Xcel Energy

Docket No.: E002/M-17-777

Response To: MN Public Utilities Information Request No. 1
Commission

Please provide a supplemental, publicly available description of the detailed methodology, including analytic equations where appropriate, for the streamlined hosting capacity analysis Xcel Energy performed.

Figure 1: Illustrative Hosting Capacity Planning Interface and Assessment

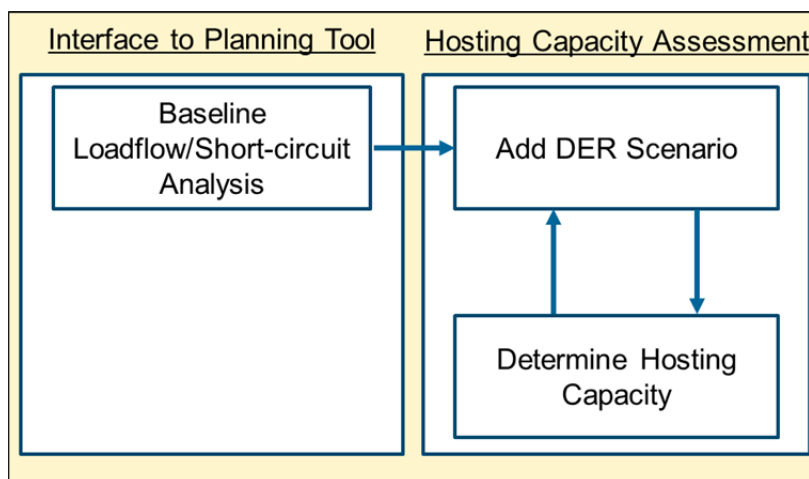
- a. The steps in Xcel's methodology (as an example see pages 27-66 of the PG&E report referenced above);
- b. Datasets, Tools, and Tool Capabilities (example from PG&E report on pages 34-36);
- c. Power System Criteria and Calculation Techniques (example from PG&E report on pages 47-66)

Once the models have been extracted, DRIVE can perform the necessary analysis. At this point, settings such as the Thresholds or type of DER expected, can be adjusted and the hosting capacity analysis is ultimately run. On average, it takes about 3-5 minutes per feeder to run the analysis. Once it has finished running, a report based on the DER allocation method is generated to establish the tabular results as seen in Attachment A of our hosting capacity report.

In the figure below, DRIVE-MAI is represented by the “Interface to Planning Tool” heading while DRIVE is represented by the “Hosting Capacity Assessment” heading. Within DRIVE, the Power System Criteria and Calculations Techniques are applied in the box labeled “Determine Hosting Capacity,” while the “Add DER Scenario” box refers to the configurability of the type of DER allocation.

Figure 1: Forecast of EV counts under Low, High, and Likely EV Penetration Scenarios

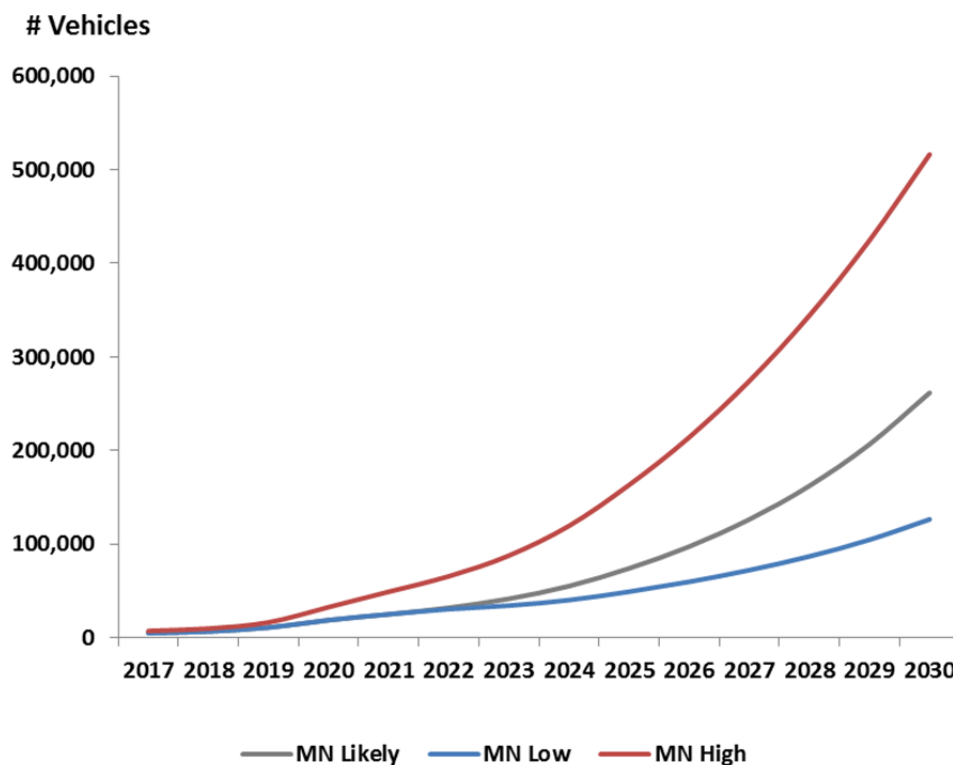
Xcel Energy states that, “Due to the nascent nature of the energy storage market in Minnesota, we excluded energy storage load characteristics from our analysis. However, in the future we plan to monitor the ability of our hosting capacity tool with regard to energy storage, and work to extract value where it exists” (page 7). Please quantify the amount of existing energy storage on Xcel’s system (number of storage installations, megawatt capacity) and provide a forecast of the increase in energy storage, including both battery storage and electric vehicles, over the next five years and the next 10 years.

We have a Low, High, and Likely forecast of electric vehicle counts in our Minnesota service territory, which is based on an internally-developed methodology that incorporates both economic payback and Bass diffusion (technology adoption) model. The scenarios are created based on gasoline prices to derive adoption estimates. The likely scenario is formulated by taking a weighted average adoption of the economic and Bass diffusion models¹. See Figure 1 below.

Figure 1: Steps Towards Interconnection

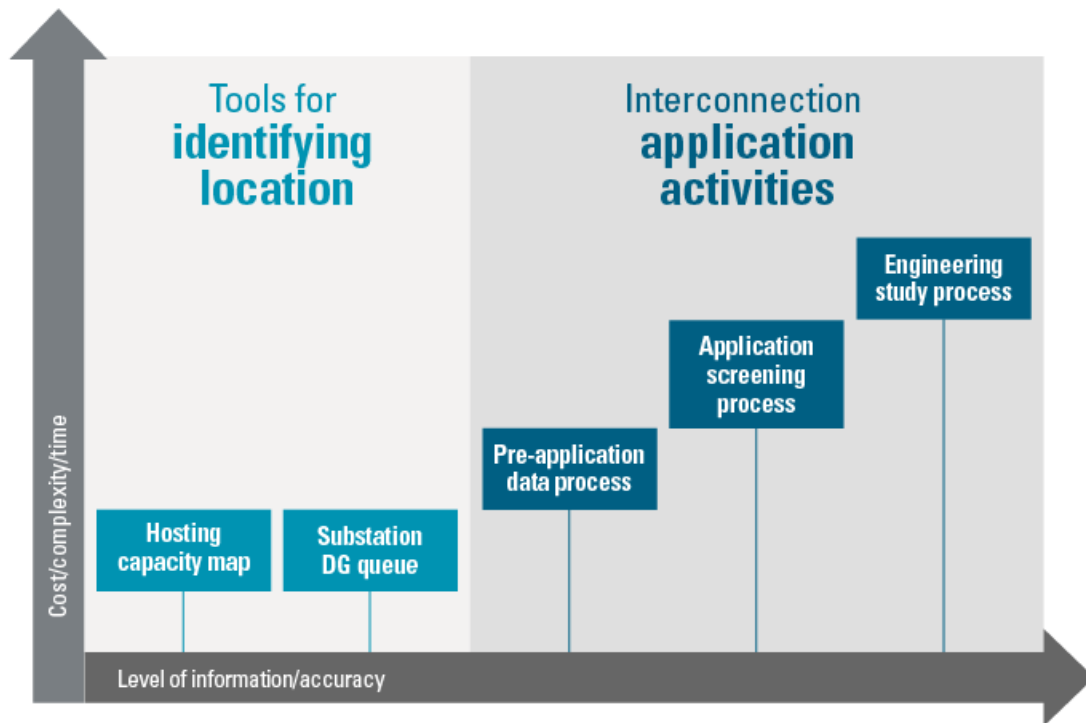
In Xcel Energy's view, how can hosting capacity analysis be used to inform or improve the utility's interconnection process?

Xcel Energy considers hosting capacity analysis and the resulting hosting capacity maps and data tables a preliminary step in the interconnection process. See the below graphic, which shows how we envision our hosting capacity tools fitting into the interconnection process. The hosting capacity tools are publicly available at no cost via our website, and provide a indication of our distribution system's ability to support distributed energy resources. Areas with a higher level of hosting capacity allow customers or developers to quickly identify potential interconnection sites that will likely have minimal impact on Xcel Energy's distribution system, thereby resulting in lower installed costs. Once a prospective interconnection location has been chosen, developers or individuals can enter into the interconnection process for increased levels of detail and refined estimates of system impacts and costs.
